# UNITED STATES PATENT AND TRADEMARK OFFICE

APPLICATION NO.	FILING DATE	FIRST NAMED INVENTOR	ATTORNEY DOCKET NO.	CONFIRMATION NO.
10/538,402	07/21/2006	Hui Wang	495152002400	3574

<b>Office Action Summary</b>	<b>Application No.</b> 10/538,402	<b>Applicant(s)</b> WANG ET AL.	
	<b>Examiner</b> BRYAN D. RIPA	<b>Art Unit</b> 1795

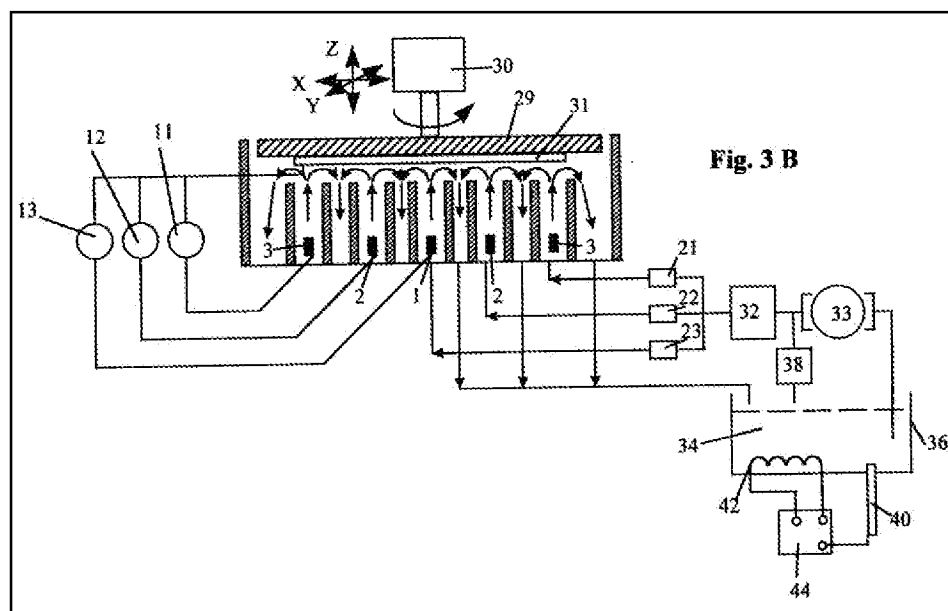
- a receptacle having a plurality of section walls (see figure 3b below showing a cup-type receptacle having a plurality of section walls; see also page 27 line 26- page 28 line 16); and
- a wafer chuck configured to hold the semiconductor wafer and to position the semiconductor wafer within the receptacle with a surface of the semiconductor wafer adjacent to top portions of the plurality of section walls (see 29 below).

Regarding claim 4, WANG teaches the apparatus for electropolishing and/or electroplating metal layers on a semiconductor wafer wherein the plurality of section walls are cylindrical and concentric (see figure 3b above).

- positioning a wafer chuck holding a semiconductor wafer within a receptacle having a plurality of section walls, wherein a surface of the semiconductor wafer to be electropolished or electroplated is positioned adjacent to top portions of the plurality of section walls (see wafer chuck 29 and figure 3b above showing a cup-type receptacle having a plurality of section walls; see also page 27 line 26-page 28 line 16).

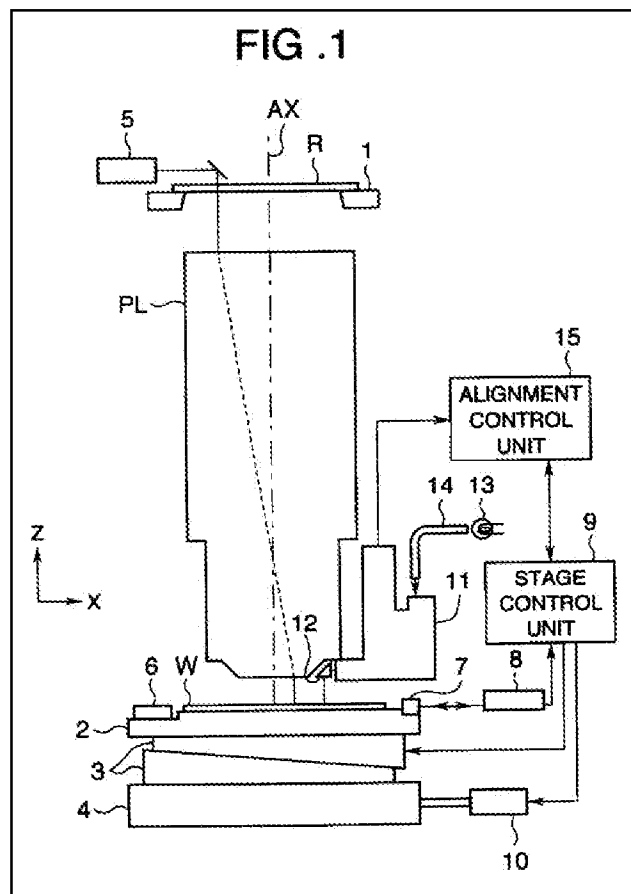
MIZUTANI, however, teaches the use of sensors to measure alignment of a wafer holder having a wafer disposed within it and an exposure apparatus (see laser interferometer 8 in figure 1 below; see also col. 3 lines 51-58).

MIZUTANI, however, teaches the use of sensors to measure alignment of a wafer holder having a wafer disposed within it and an exposure apparatus (see laser interferometer 8 in figure 1 above; see also col. 3 lines 51-58).
